KMR.CDD.MiQ.1916-1918.01(N)

With reference to his memo. dated 11th June 1918 submitting amended plan of the outhouses under construction on plot No. 8G, I-5, Garden Quarter, Mr. Ghulam Hussein Kassim is informed that the same is approved and permission to build in accordance therewith hereby granted.

Undersigned has the honour to forward herewith an amended plan for outhouses of bungalows on his plot No.86, I-5 Garden Quarter for the approval of the Engineer, Karachi Municipality.

AMENDED PLAN
HOUSES ON PLOT N^o 8G SHEET, I-5
GARDEN QUARTER.
SCALE 8 FT - 1 INCH.

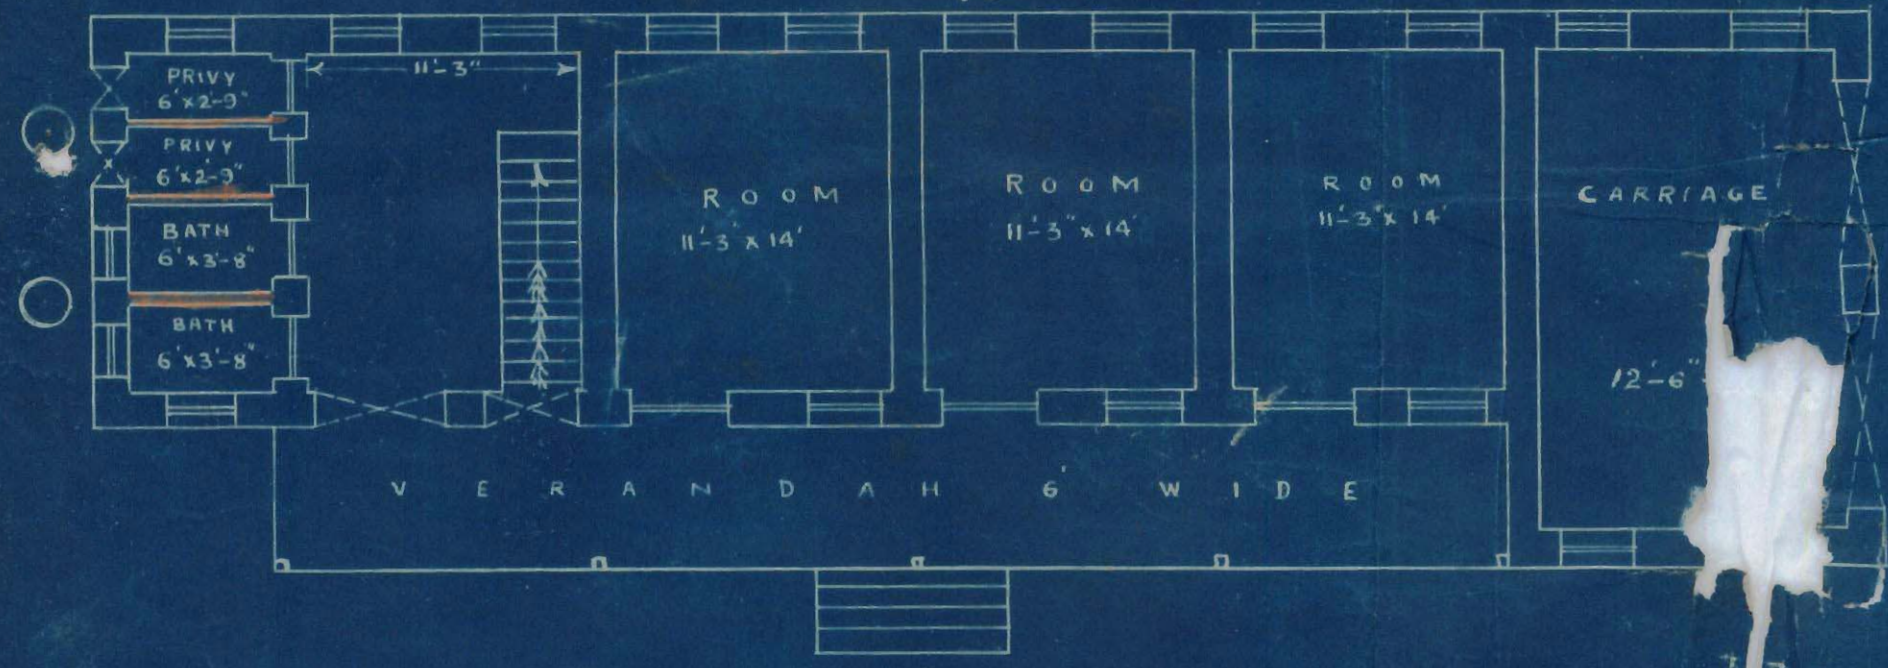
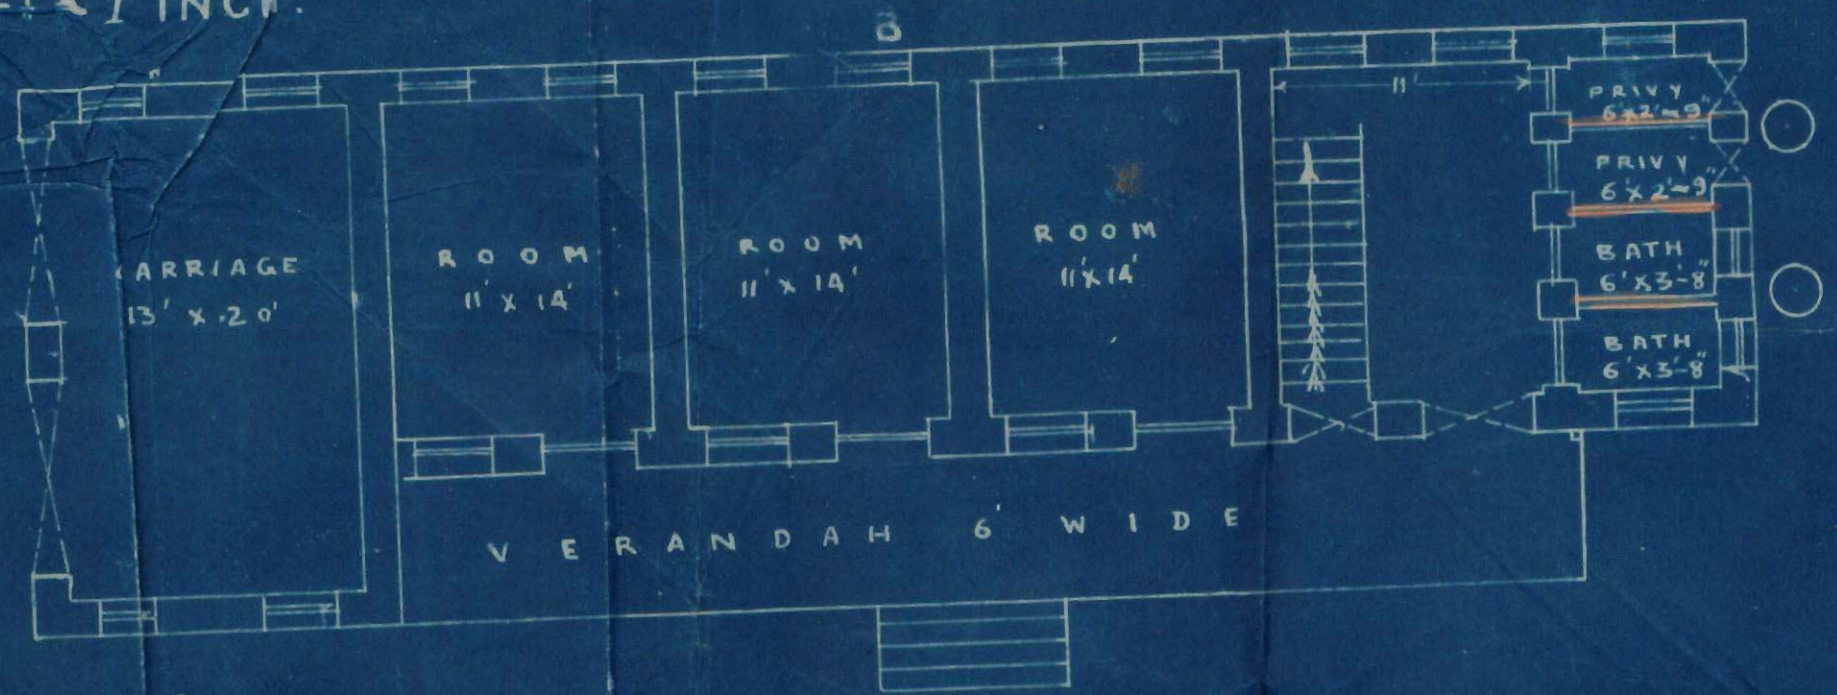
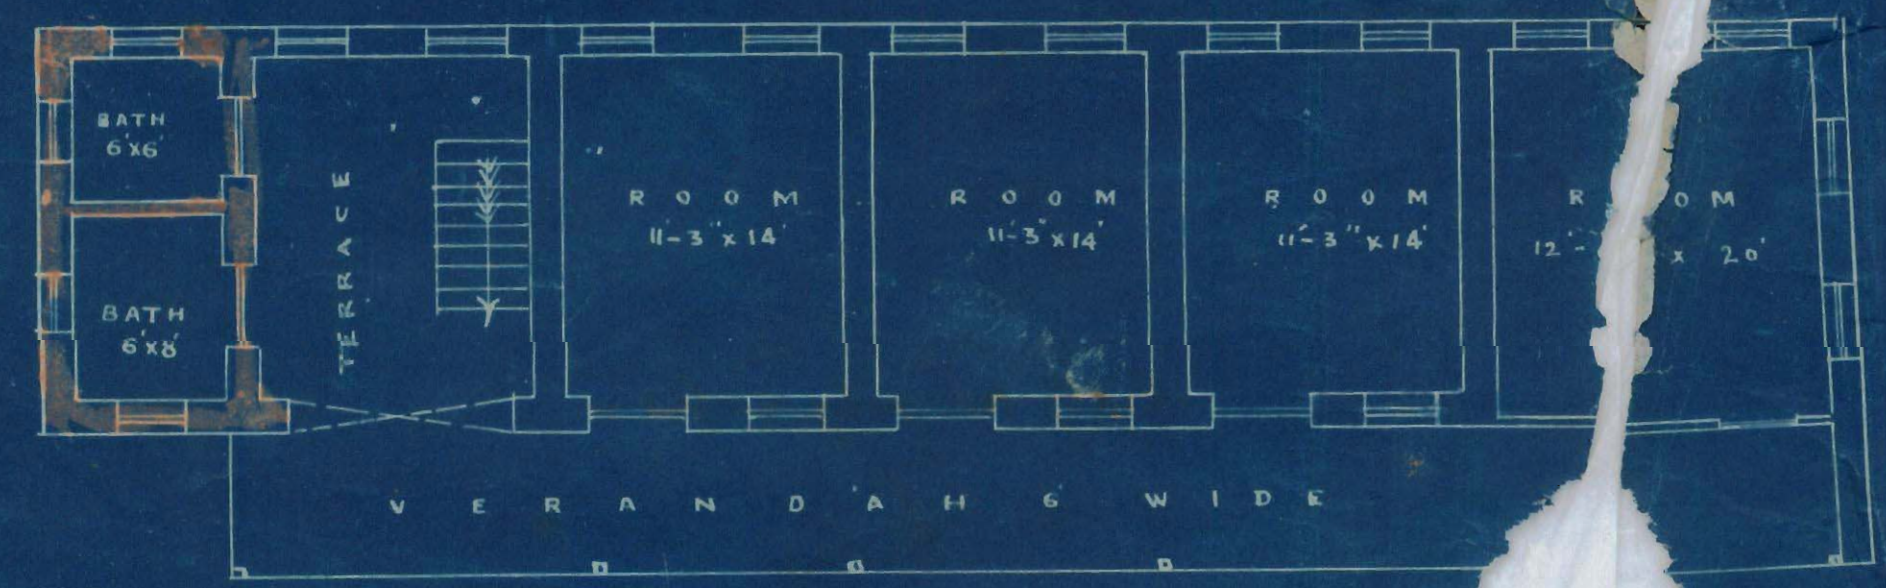
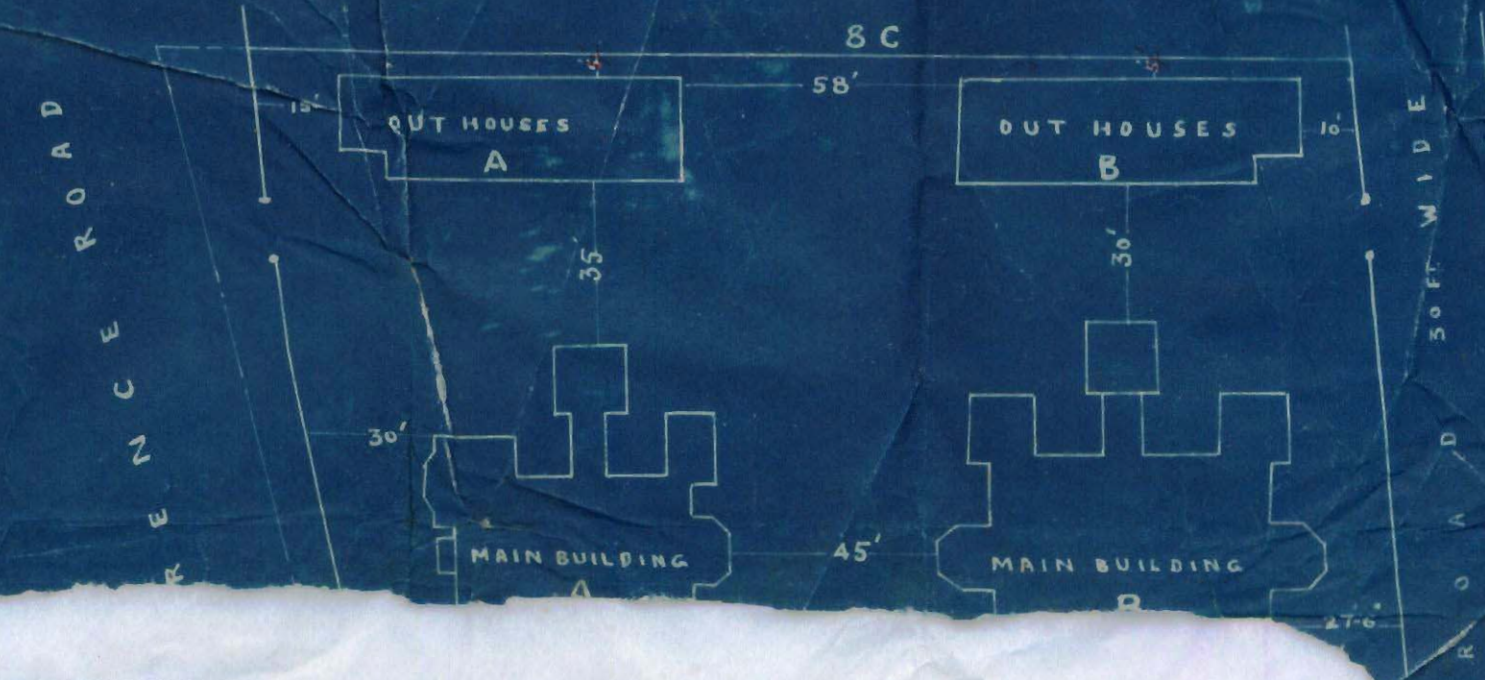
As the amendments are slight as shown in red on the plan the work has been started in anticipation of his sanction.

F.C. attached
and has to report that
there seems no objection
to approve of the same
